<b>Docket Number:</b>	24-OPT-02
<b>Project Title:</b>	Compass Energy Storage Project
<b>TN #:</b>	258090-1
<b>Document Title:</b>	Data Request Response #1_Part I
<b>Description:</b>	N/A
<b>Filer:</b>	Erin Phillips
<b>Organization:</b>	Dudek
<b>Submitter Role:</b>	Applicant Consultant
<b>Submission Date:</b>	7/26/2024 8:29:44 PM
<b>Docketed Date:</b>	7/29/2024

CEC Data Request Response No. 1

# Compass Battery Energy Storage Project

**CALIFORNIA ENERGY COMMISSION**

DR ALT-1. Updated Figure 5-1A, Alternative Locations Land Use

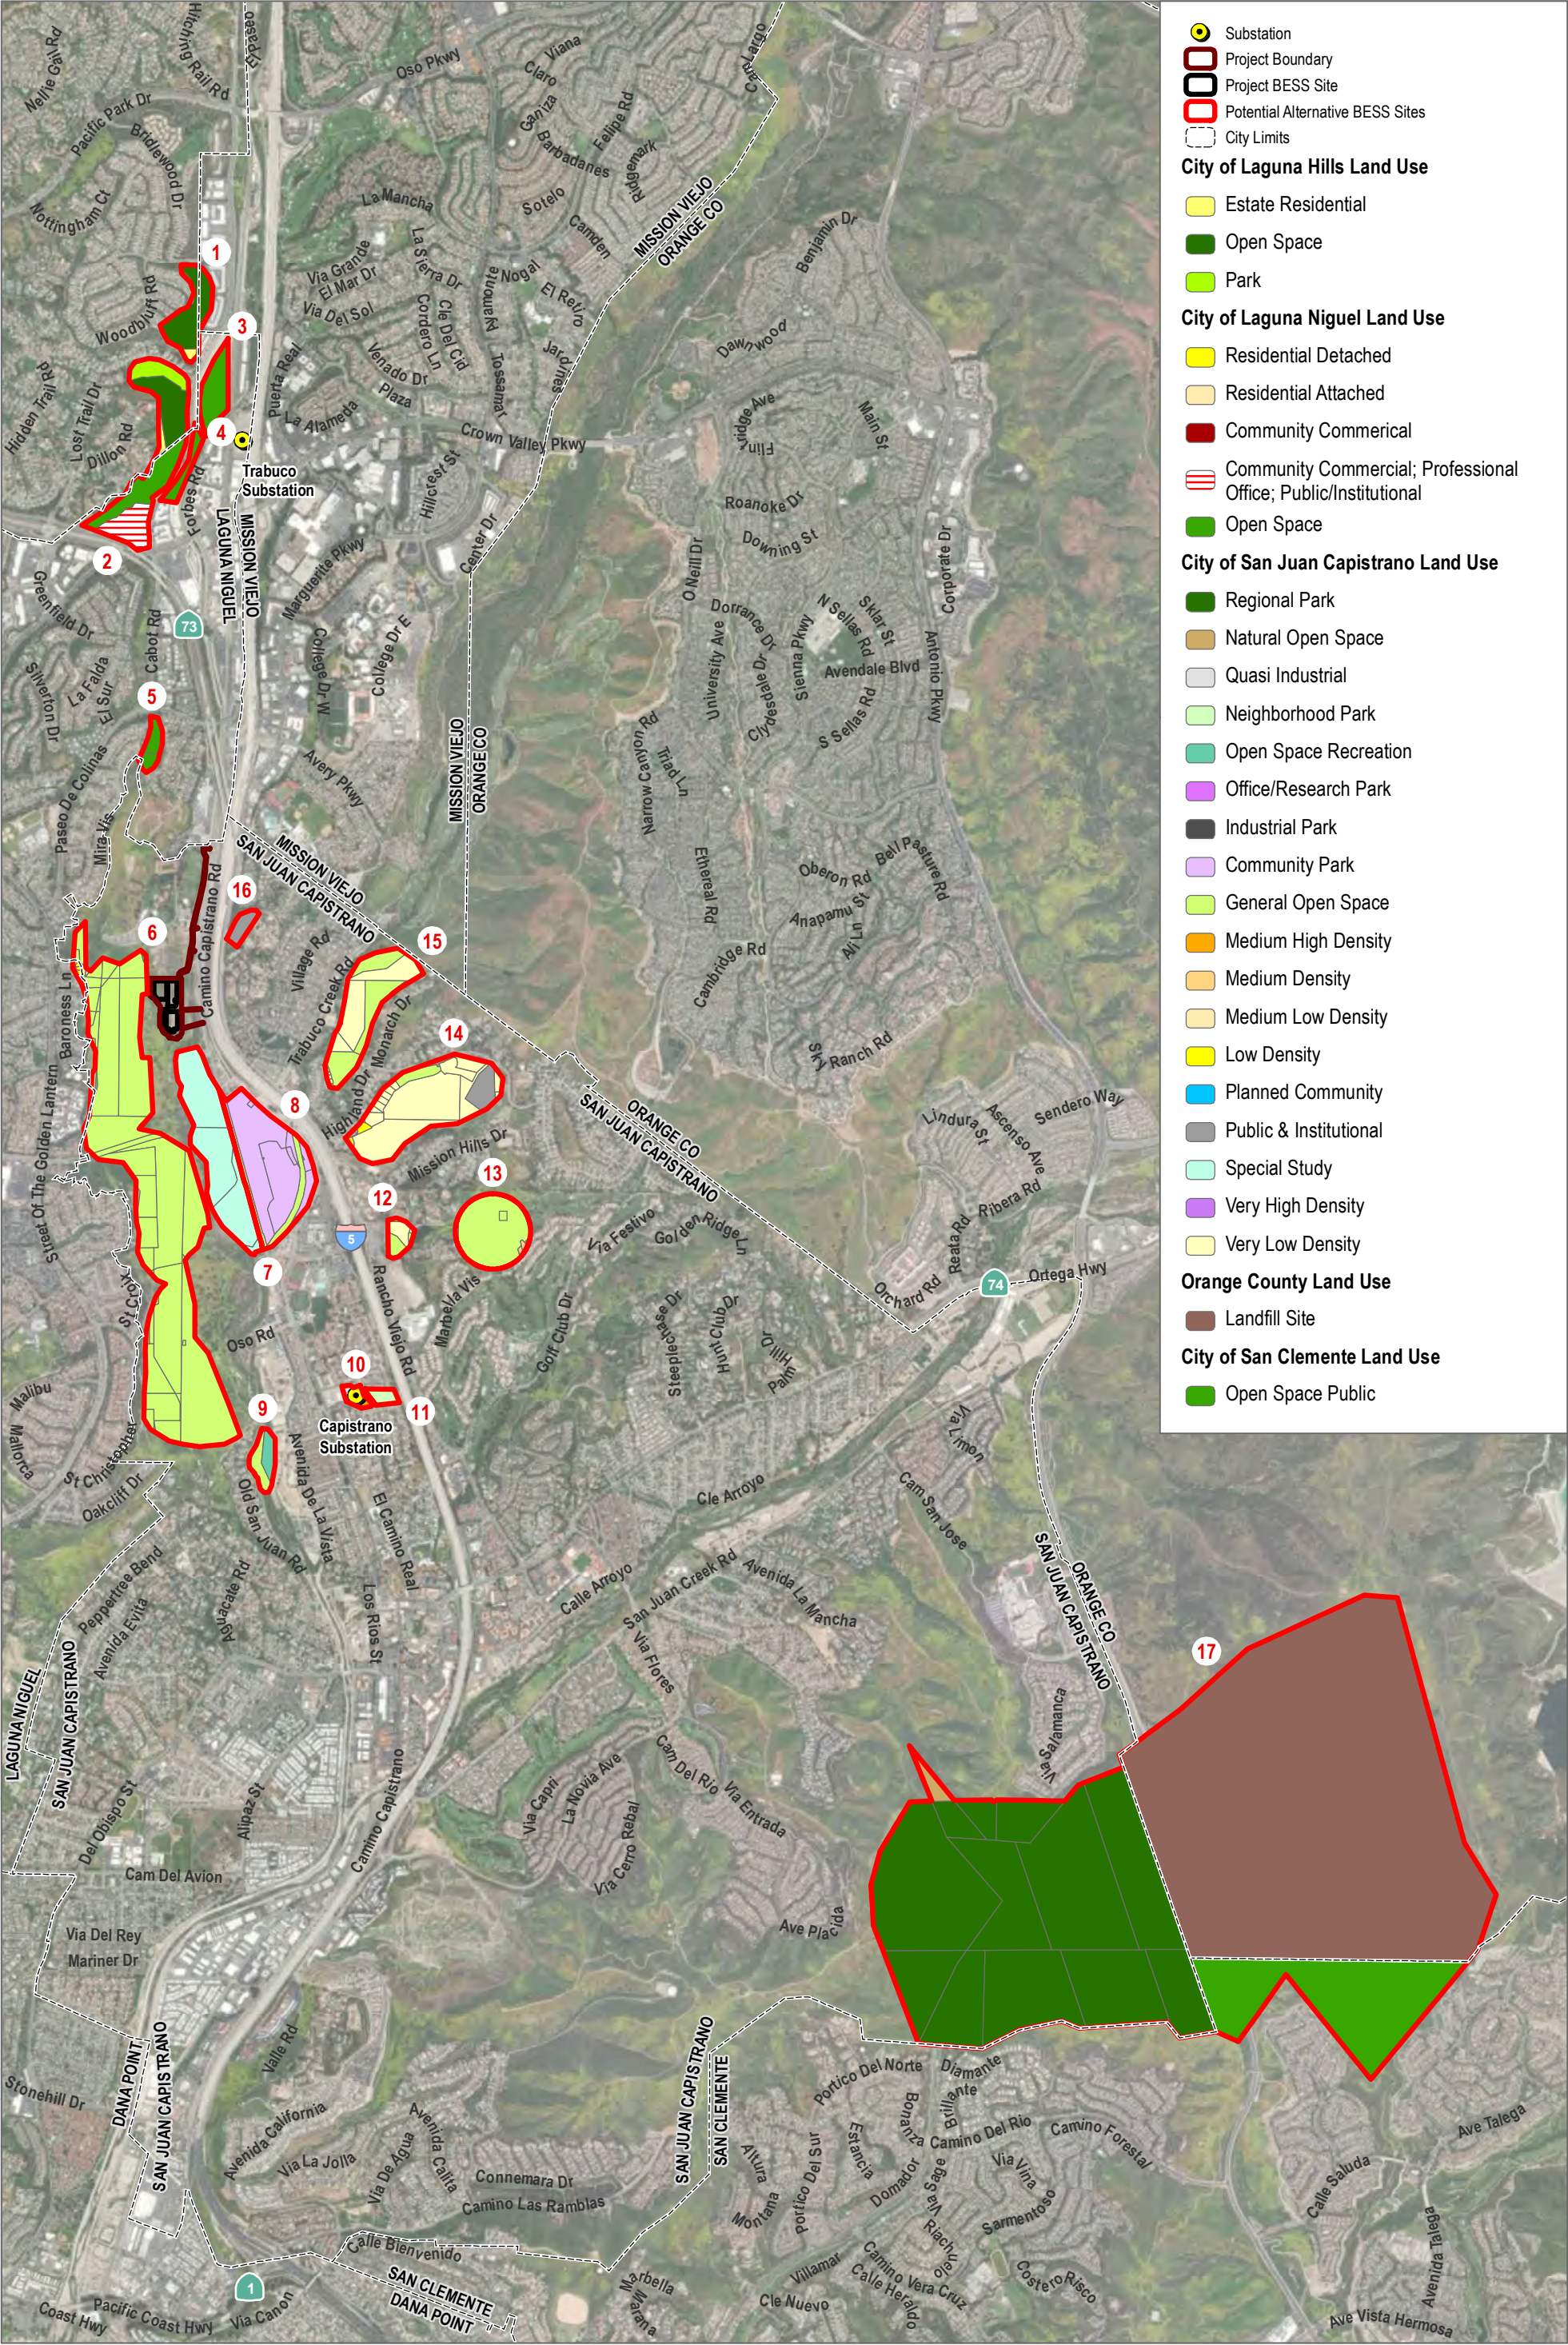
**Response:** As shown in Figures 1 and 2 of this document, Figures 5-1A and 5-1B have been revised to accurately show the location of all 17 sites considered in the alternatives analysis. Alternative Site 16 (east of Interstate [I] 5, uphill from Rancho Viejo Road, designated Public Institutional) was incorrectly labeled as Alternative Site 14 in the prior iteration and has now been correctly identified as Alternative Site 16 in the figures. Alternative Site 17 (Prima Descheca Landfill) has also been added to the figures.

**FIGURE 4**  
**DR LAND-1. Updated Figure 4-1, Cumulative Projects**  
Compass Battery Energy Storage Project

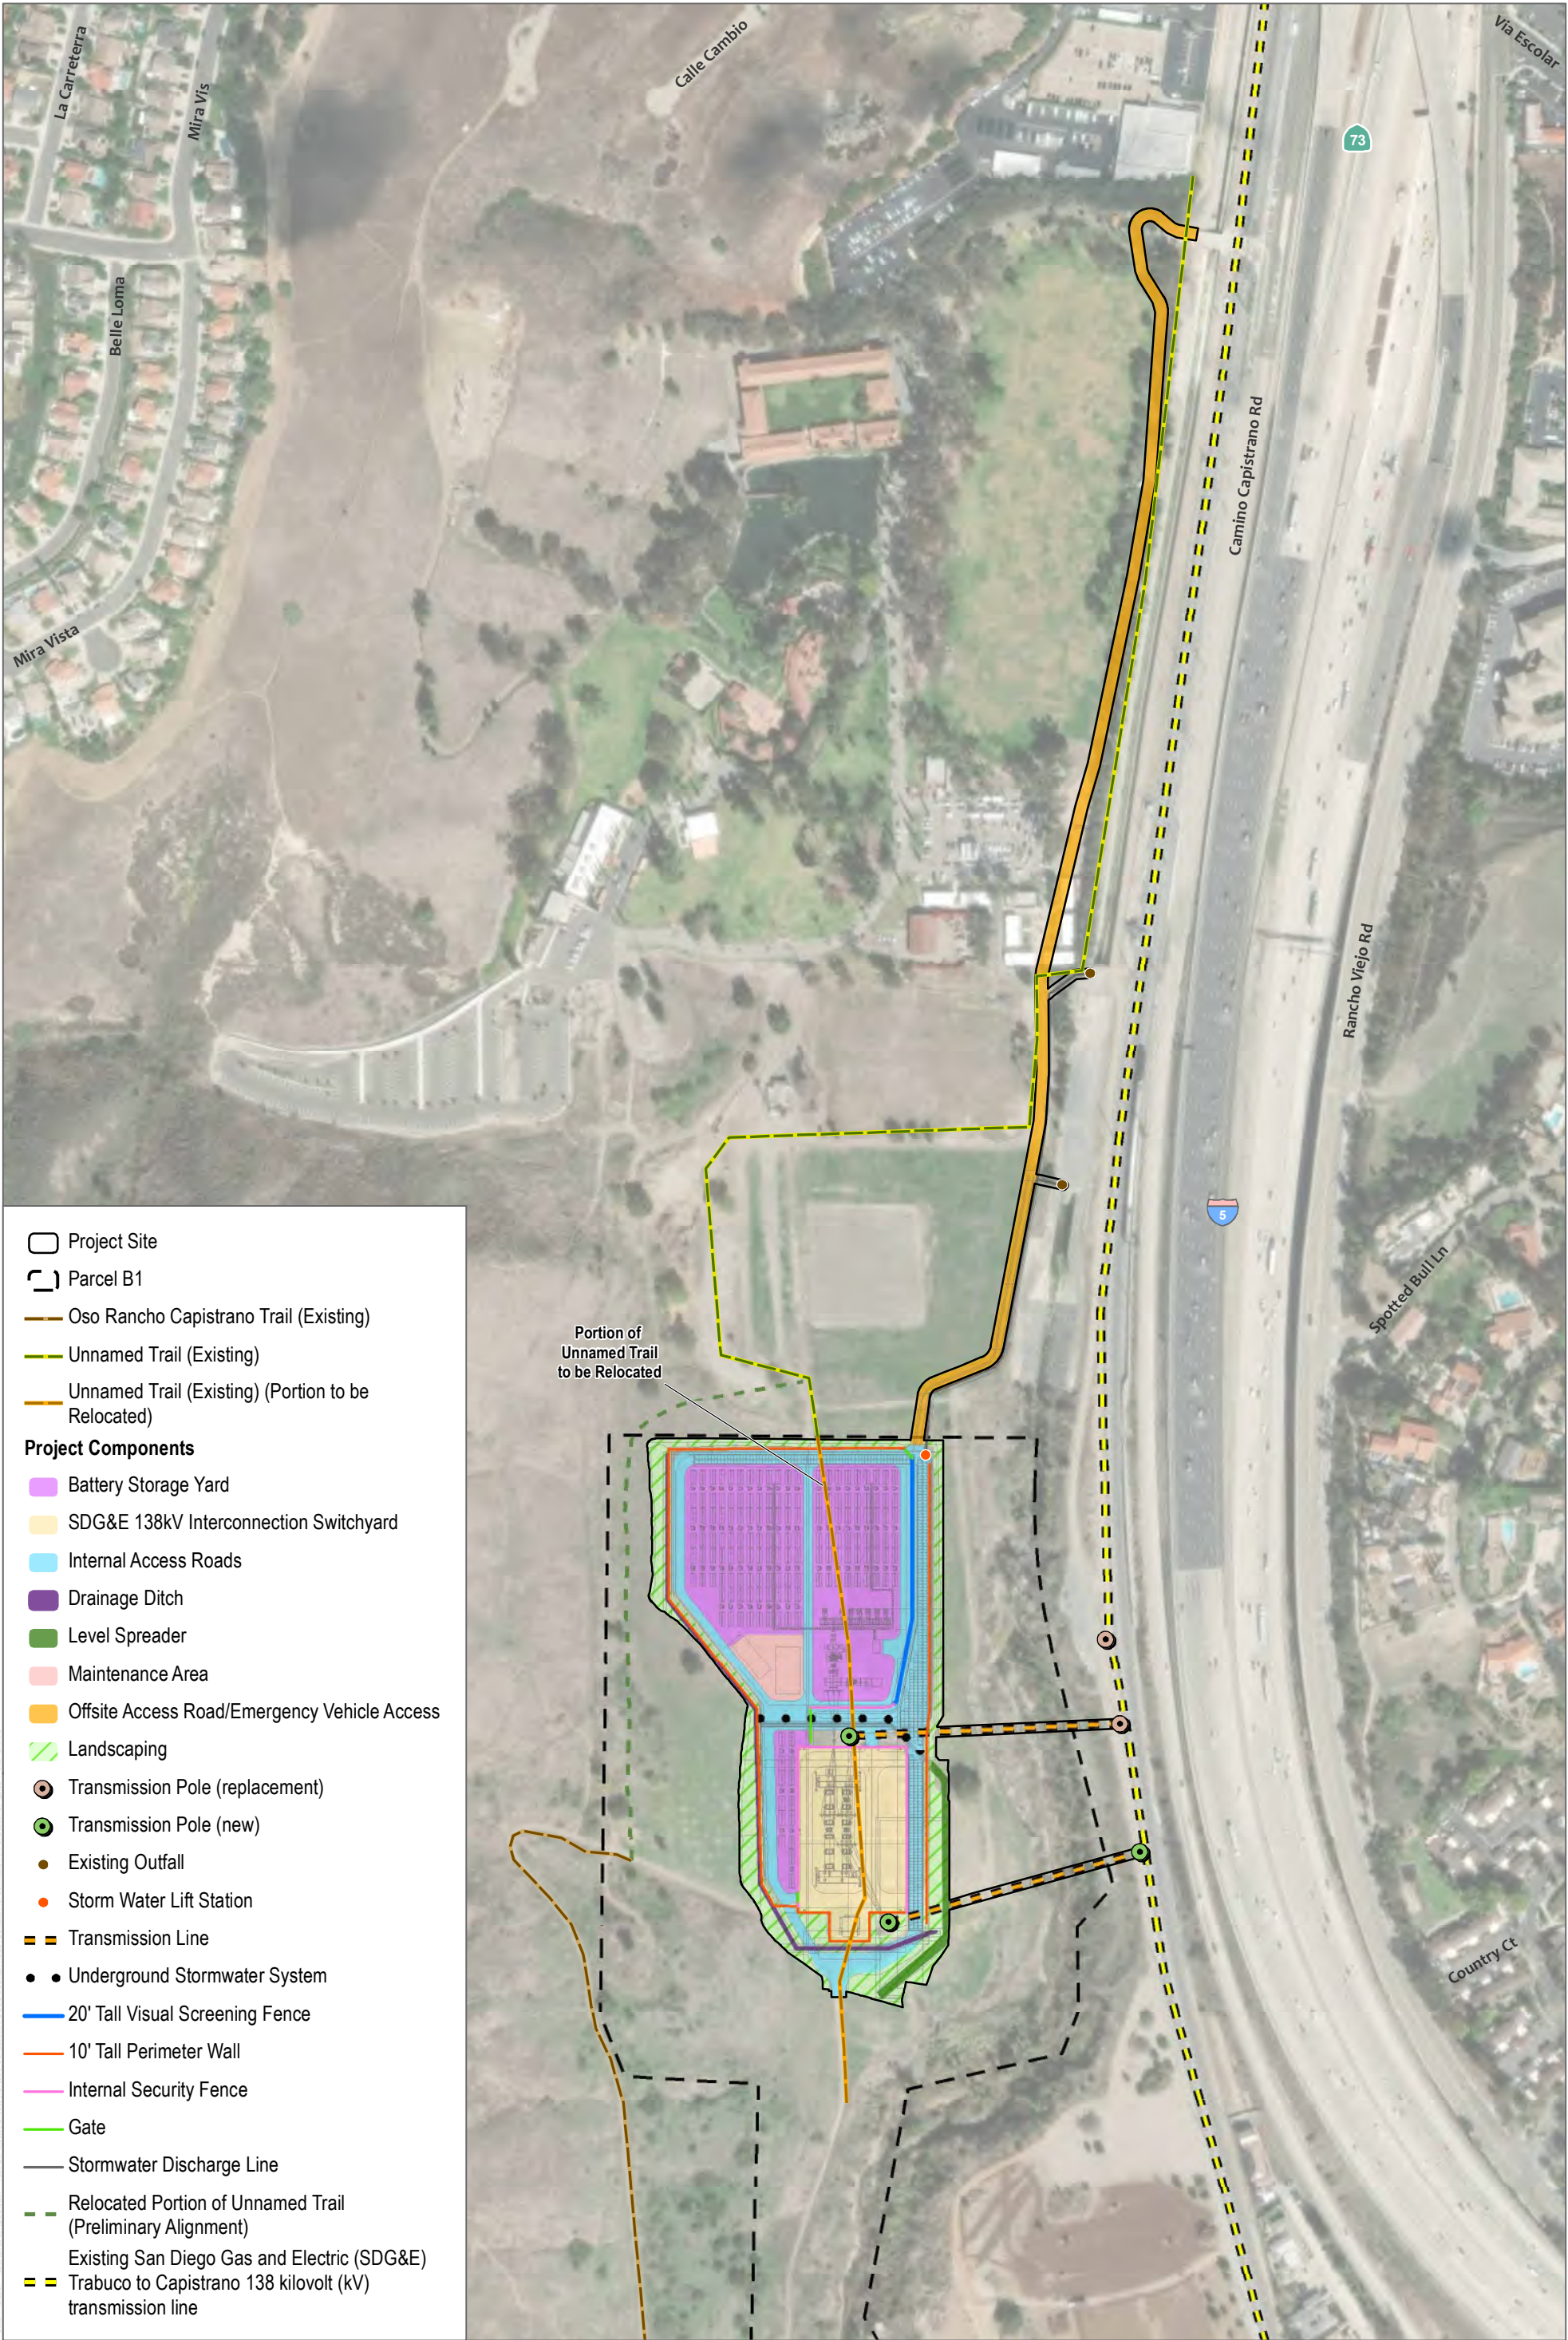
**DR LAND-1:** Please add item 14 to the legend and to Figure 4-1.

**Response:** Item 14, Industrial Housing Overlay, has been added to Figure 4-1 (see Figure 4 of this document).
